Preview Solution CBR-2362-3

Mack - Carrier Nut Adhesive Change - Part Number 22952162

Published 9 April 2025

This solution concerns part number 22952162, shown in the diagram below.

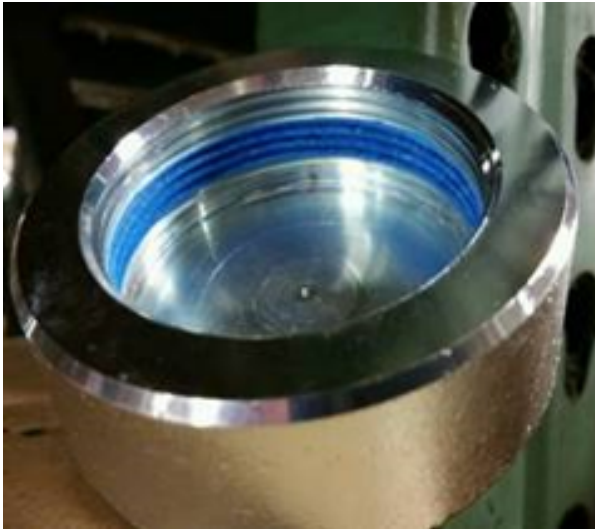
Due to a change in the type of adhesive used to secure the rear input nut on Mack drive axles, **a new cure time MUST BE observed when replacing the nut.** See below for more information.

Old Part

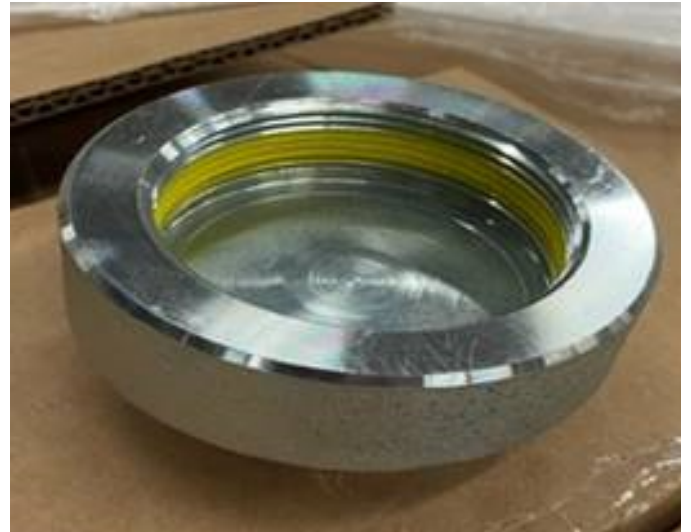
The current adhesive which is blue in color, is being discontinued. Due to this, the adhesive used to secure the carrier nut has been changed to a yellow-colored product. Examples of both are shown below.

New Part

The yellow adhesive has a MINIMUM cure time of FOUR HOURS.

A minimum of 4 hours should be allotted following replacement with a part that uses the yellow adhesive before the vehicle is test driven or returned to service in order for the adhesive to properly cure.
